# Access Compliance Report

## Public Rights-of-Way

### (Curb Ramps)

Intersection ID: 9362	Main Street: DELTA LAKE DR	Cross Street: ROCKMOOR RIDGE RD	Location: NW
ADA ID: 6AC3315AFDE4	Ramp Type: Perp	Initial Pass/Fail: Fail	Overall Compliance: No
			Severity Score: 13.75

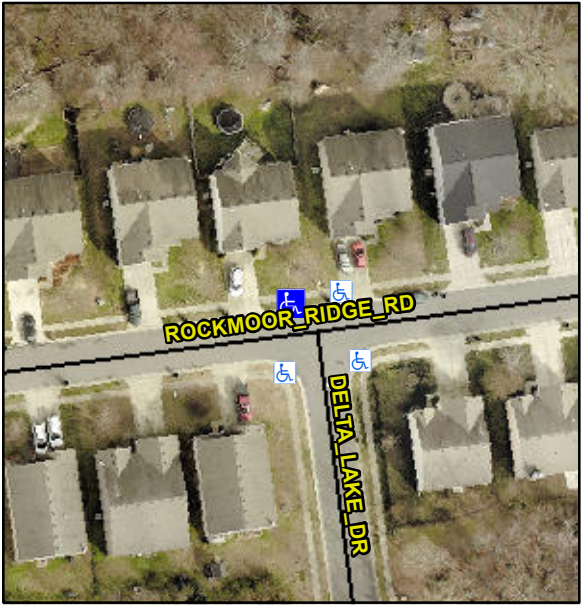
Codes/Mitigation Info/Possible Solution		Field Measurements/Component Compliance					
	Possible Solutions:						
	Remove & Replace Entire Ramp.						
		Compliance	Description	Data	Compliance	Description	Data
		N/A	Ramp Length (in)	48.0	No	Ramp Slope (%)	9.8
		Yes	Ramp Width (in)	48.0	Yes	Ramp XSlope (%)	3.1
		N/A	Flare Type LT	N/A	N/A	Flare Type RT	N/A
		N/A	Flare Slope LT (%)	N/A	N/A	Flare Slope RT (%)	N/A
		N/A	Flare Traversable LT?	N/A	N/A	Flare Traversable RT?	N/A
		N/A	Landing Length (in)	N/A	N/A	DWS Provided?	N/A
		N/A	Landing Width (in)	N/A	N/A	DWS Contrast?	N/A
<p>Surveyor Notes:</p> <p>N/A</p>		N/A	Landing Slope (%)	N/A	N/A	DWS Length (in)	N/A
		N/A	Landing X Slope (%)	N/A	N/A	DWS Full Width?	N/A
		N/A	Landing Curb? (Y/N)	N/A	N/A	DWS Offset (in)	N/A
		N/A	Shared Landing?	N/A			
		N/A	Gutter Ponding?	N/A	N/A	Gutter Slope (%)	N/A
		N/A	Gutter Lip Ht (in)	N/A	N/A	Gutter X Slope (%)	N/A
		N/A	Painted X Walk1?	No	N/A	Painted X Walk2?	N/A

X Walk 1 Direction	To S		X Walk 2 Direction	N/A
		N/A	X Walk 1 Width (in)	N/A	N/A	X Walk 2 Width (in)	N/A
			X Walk 1 Slope (%)	2.1		X Walk 2 Slope (%)	N/A
<p>PROW/ADA:</p> <p>Not Found, R304.2.2</p>			X Walk 1 X Slope (%)	3.1		X Walk 2 X Slope (%)	N/A
		N/A	Ramp inside XWalk1?	N/A	N/A	Ramp inside XWalk2?	N/A
			Road Slope (%)	N/A	N/A	Clear Space?	N/A
			Road X Slope (%)	N/A	N/A	Clear Space to XWalk (in)	N/A
		N/A	Any Obstructions?	N/A	N/A	Storm Grate/Utility Hazard?	N/A
			Obstruction Type			Storm Grate/Utility Type	
					N/A		N/A
					Yes	Surface Condition? (G/P)	Good
Total Cost:		\$	1850.00
